WAKE COUNTY HEALTH DEPARTMENT WELL AND SEWAGE SITE, LOCATION PERMIT

Pin # 1708.02774508 Project # 952412 KB 8.3.95

Subdivision Name: Cross Gate Lot No. 106 Section or Block No. _____

Final Layout Changed Layout Due to Basement & Plumbing Change 2 Lines follow Contour 9' on Center 7-13-95 ETD

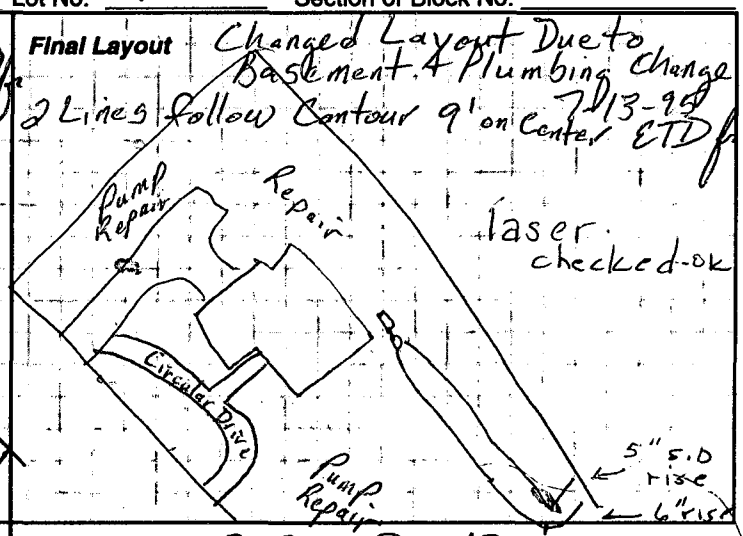
Comments: Keep system shallow follow contour, stay min 50' off road, keep 10' off property line new line comes in contact with existing drainfield for hall type access street no problem though

FINAL SURVEY

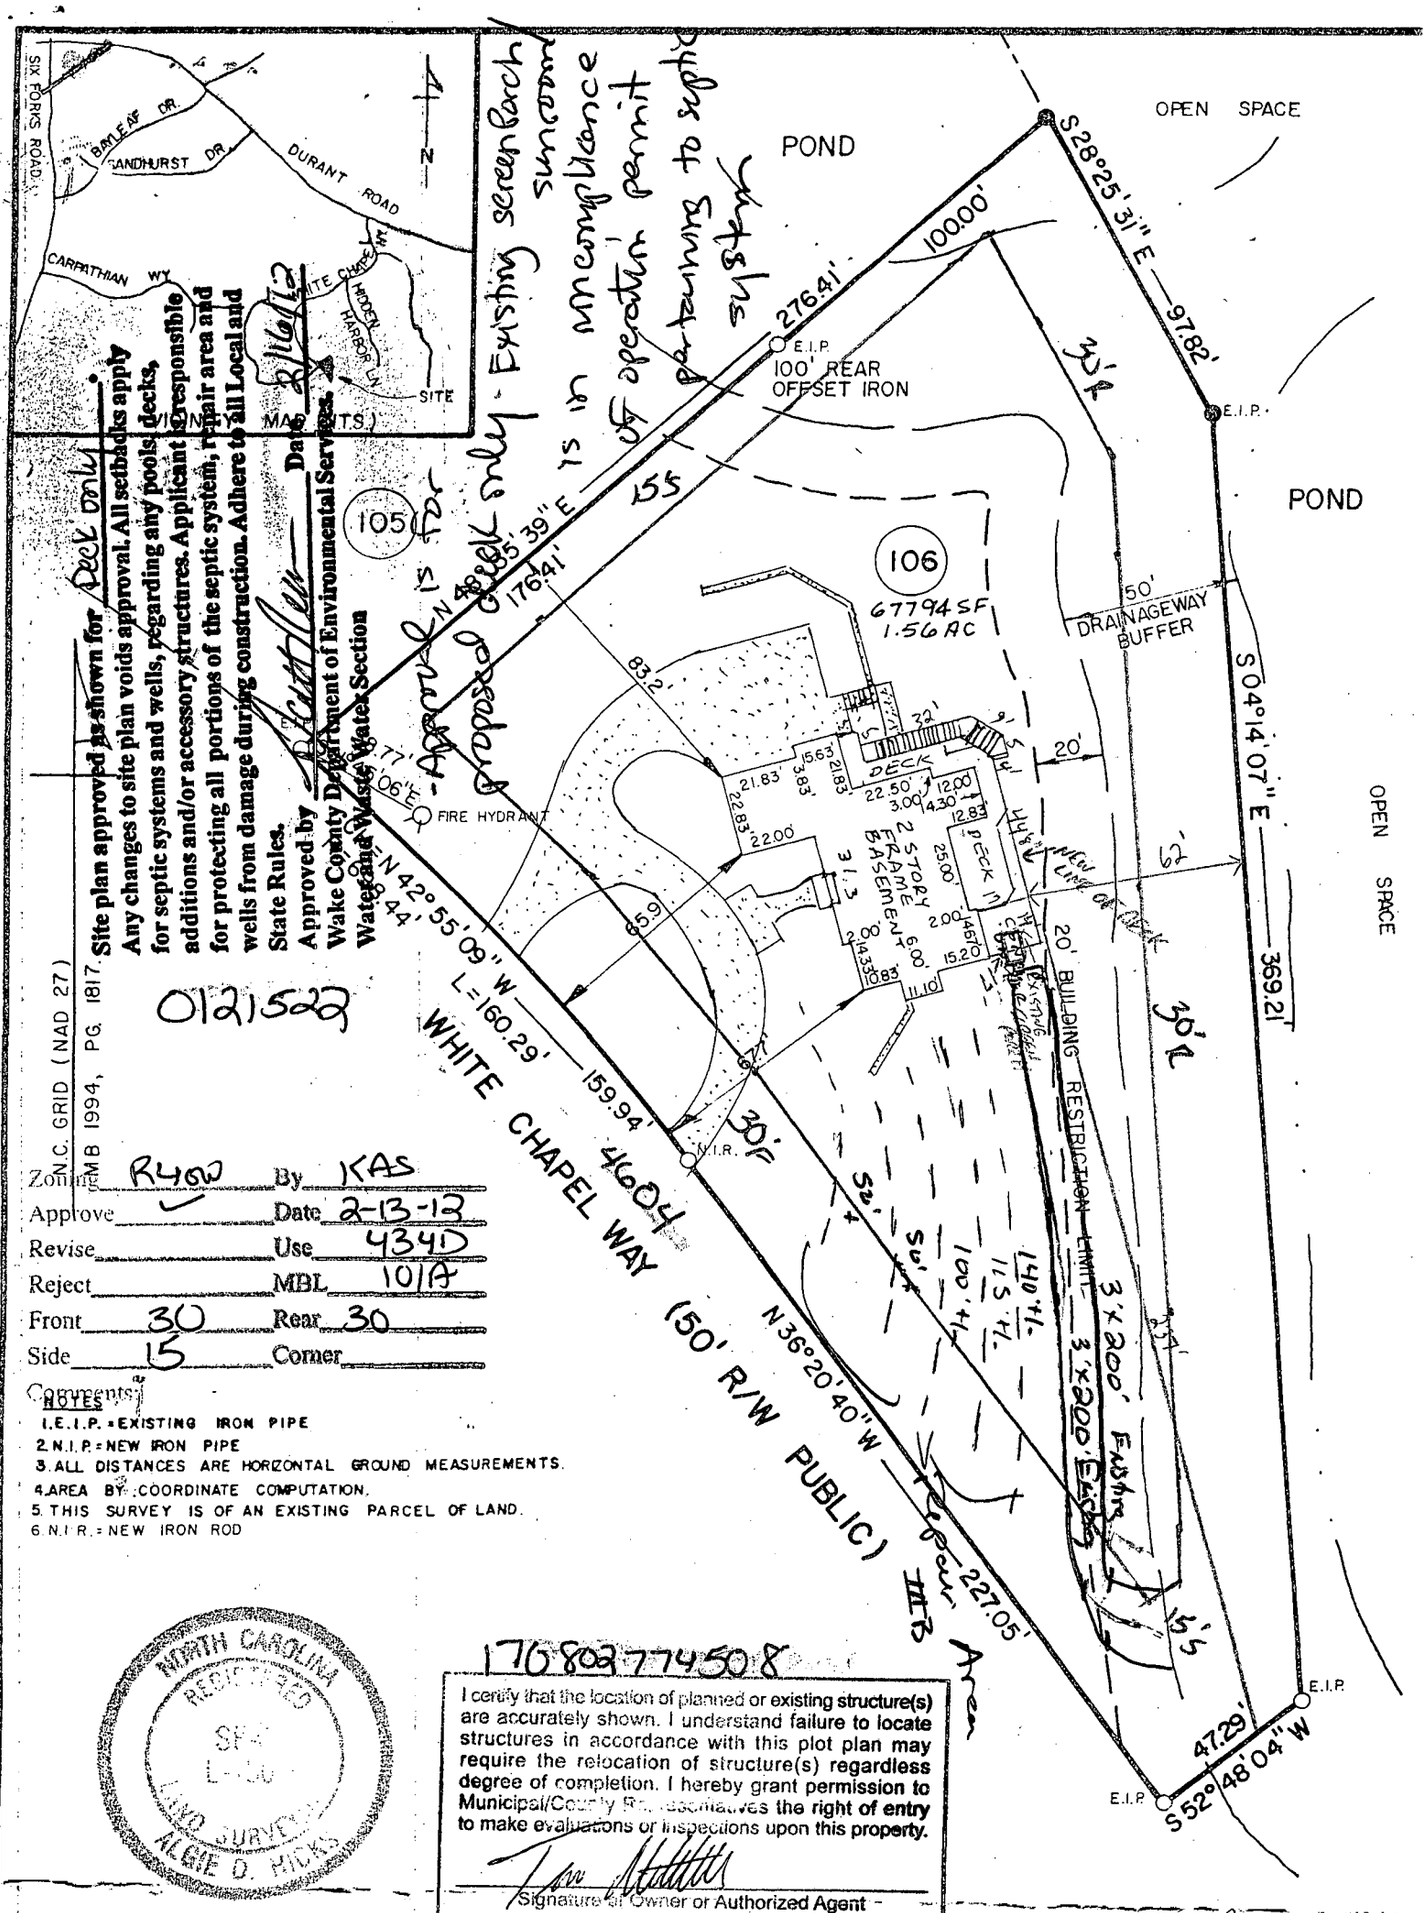
Existing screen porch & sunroom is in encroachment of septic pertaining to septic system. Proposed deck only - Approved for deck only

Site plan approved as shown for deck only. Any changes to site plan voids approval. All setbacks apply for septic systems and wells, regarding any pools, decks, additions and/or accessory structures. Applicant responsible for protecting all portions of the septic system, repair area and wells from damage during construction. Adhere to all Local and State Rules.
Approved by _____ Date _____
Wake County Department of Environmental Services
Water and Waste Section
